ADDENDUM NUMBER 1

PROJECT: Replace Roof, Mullen Building
2009-069M21

DATE: 06/29/22

OWNER: Trinidad State College
600 Prospect St
Trinidad, CO 81082

3 TYP. ROOF CONSTRUCTION
A9.01 SCALE: 1-1/2" = 1'-0"

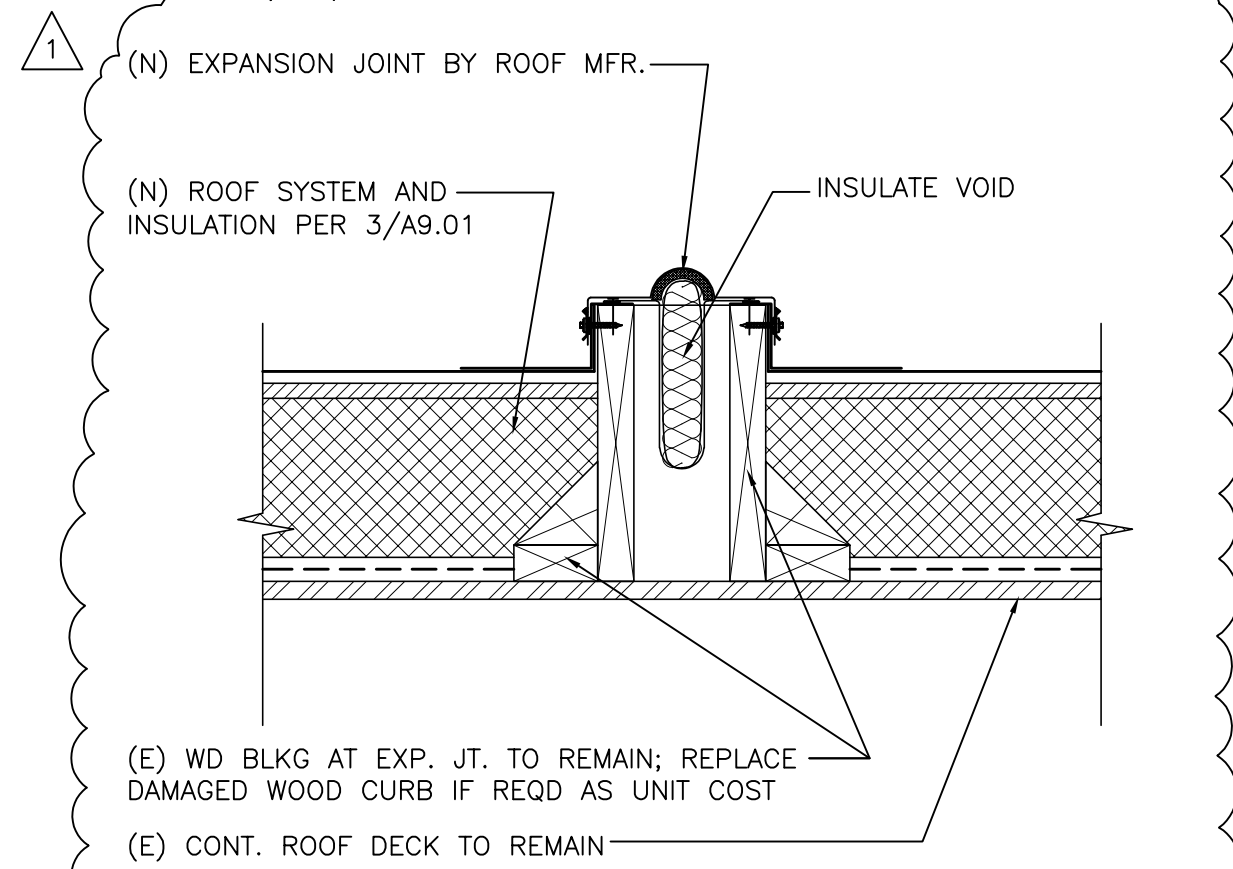
4. Q: Detail 3/A9.01 indicates a vapor barrier and substrate board installed. The specs mention nothing of it. Which is true?
A: Vapor barrier is considered an auxiliary material per the submitted roof manufacturer's roofing system. Bidders shall assume that a vapor barrier is required to be provided per detail 3/A9.01 and that any existing vapor barrier in place will be too damaged during tear-off for re-use. Specification section 075323 has been clarified.

24. Clarifications: Specification Section 07 5323 has been modified per the attached document to clarify the following items:

Vapor Barrier

Elimination of the substrate board requirement

Change to a Class C minimum roofing assembly.

5 (E) STEPPED PARAPET CAP
A9.01 SCALE: 1-1/2" = 1'-0"

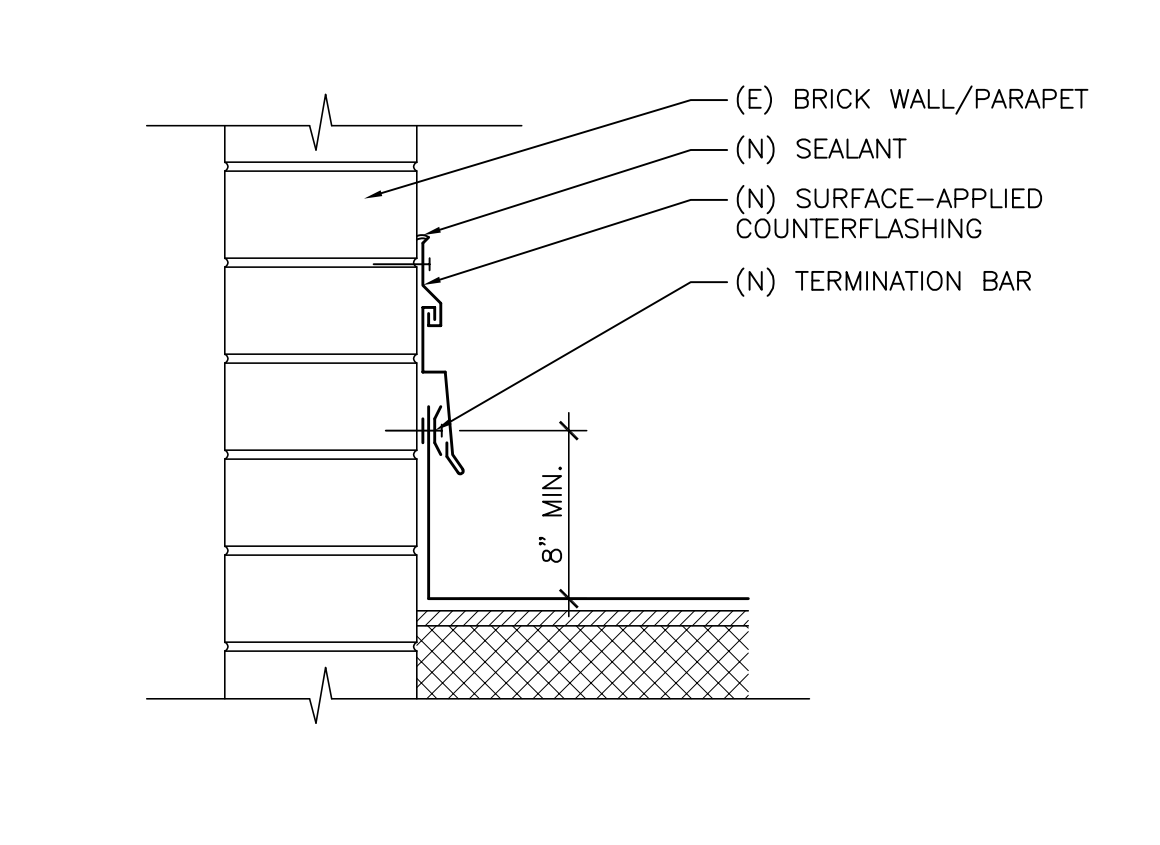
14. Q: Please confirm that the asbestos is only to be found in the wall flashings and not the entire roof.
A: See response to question #3 above.
15. Q: What is the new detail for the parapet with the mortar?
A: See attached revised details SK-1, SK-2, SK-3 & SK-4. They replace details 2/A9.01 and 5/A9.01

G0.00, A1.01, A1.02 & A9.01
28. Revisions: Sheet A9.01, detail 2/A9.01 is to be replaced with attached drawings SK-1 & SK-2. Detail 5/A9.01 is to be replaced with attached drawings SK-3 & SK-4. (These changes have not been identified on the revised A9.01 sheet.) These SK drawings are representative of the range of parapet conditions and all similar conditions shall apply the principles of these details.
29. Additive Alternate #3 has been newly defined in this Addendum. It shall include the structural bracing and roofing work associated with the four masonry pilasters on the north side of the building. These have been identified on sheets A1.01, A1.02 & A9.01.

11 CONDUIT SEALANT PAN
A9.01 SCALE: 3" = 1'-0"

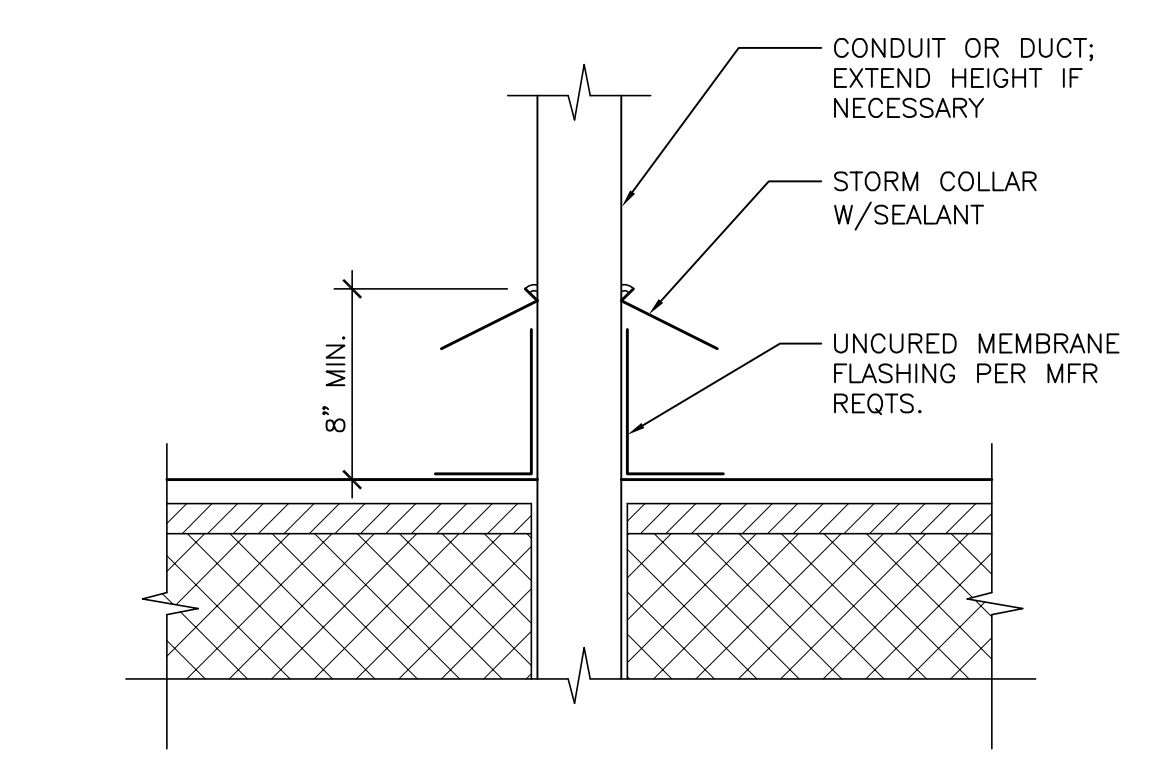
2. Q: Detail 11/A9.01 would it be satisfactory to use a field wrap or roof jack in these areas?
A: A roof jack or boot flashing would be acceptable if approved by submitted roof manufacturer for single penetrating item locations only. If there are multiple penetrants, then the sealant pan is required.
